PFIS Critical Design Review Comments

SSWG - CDR Comments

Major Concerns- III

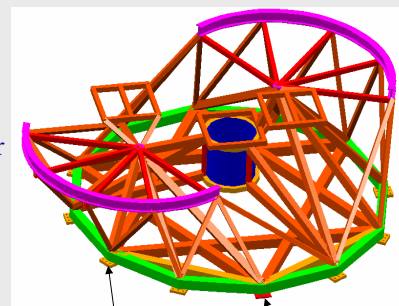
- Concern that the flexure would not behave in a repeatable way due to stiction in the Z-pads
 - The current design couples the invar instrument structure to the steel rotator ring with an X-Y pin and a Y-slot, while support in Z is in 12 pads which are free in X-Y.
 - If there is stiction at these pads, the instrument will flex unpredictably as the temperature changes.
 - Analysis in progress: We have found a surface treatment that minimizes friction. Initial estimate shows < 5 micron stiction events.

NIR Beam Envelope

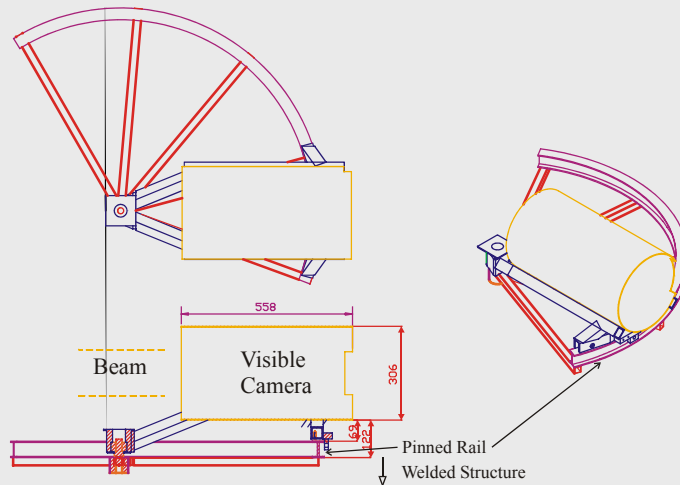
- The project should consider full mechanism spares
 - we estimate the cost of mechanism spares to be ~\$30K/ major mechanism> Recommendation: No.
 - desired spares need to be identified as soon as possible to allow efficient ordering of parts
 - per the SOW, spares are not part of instrument cost- they are purchased separately by the SALT project
- The project should consider allowing a larger envelope for the NIR beam
 - We are studying pinning the curved I-beam on the NIR side, rather than welding it. Would allow up to ~120 mm additional envelope below NIR camera.
 - A larger redesign would invalidate the truss concept, and would require a schedule slip
